Access Compliance Report

Public Rights-of-Way

(Curb Ramps)

Intersection ID: 50583	Main Street: GRAND_FIR_RD	Cross Street: LONGSTRAW_RD	Location: SW
ADA ID: 0554CAF57D44	Ramp Type: Perp	Initial Pass/Fail: Fail	Overall Compliance: No
Codes/Mitigation Info/Possible Solution		Field Measurements/Component Compliance	
Severity Score: 12.5

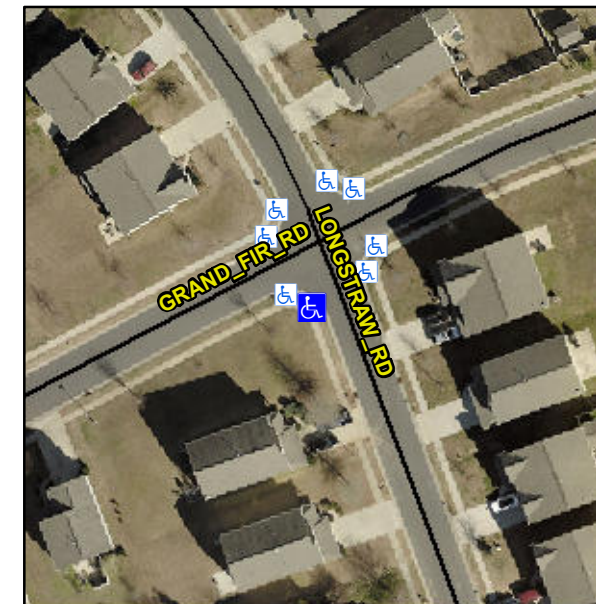
Not Found, R304.5.3

Compliance	Description	Data	Compliance	Description	Data
N/A	Ramp Length (in)	48.5	Yes	Ramp Slope (%)	6.1
Yes	Ramp Width (in)	48.0	No	Ramp XSlope (%)	6.7
N/A	Flare Type LT	N/A	N/A	Flare Type RT	N/A
N/A	Flare Slope LT (%)	N/A	N/A	Flare Slope RT (%)	N/A
N/A	Flare Traversable LT?	N/A	N/A	Flare Traversable RT?	N/A
N/A	Landing Length (in)	N/A	N/A	DWS Provided?	N/A
N/A	Landing Width (in)	N/A	N/A	DWS Contrast?	N/A
N/A	Landing Slope (%)	N/A	N/A	DWS Length (in)	N/A
N/A	Landing X Slope (%)	N/A	N/A	DWS Full Width?	N/A
N/A	Landing Curb? (Y/N)	N/A	N/A	DWS Offset (in)	N/A
N/A	Shared Landing?	N/A			
N/A	Gutter Ponding?	N/A	N/A	Gutter Slope (%)	N/A
N/A	Gutter Lip Ht (in)	N/A	N/A	Gutter X Slope (%)	N/A
N/A	Painted X Walk1?	No	N/A	Painted X Walk2?	N/A
	X Walk 1 Direction	To E		X Walk 2 Direction	N/A
N/A	X Walk 1 Width (in)	N/A	N/A	X Walk 2 Width (in)	N/A
	X Walk 1 Slope (%)	1.4		X Walk 2 Slope (%)	N/A
	X Walk 1 X Slope (%)	4.5		X Walk 2 X Slope (%)	N/A

Remove & Replace Entire Ramp.
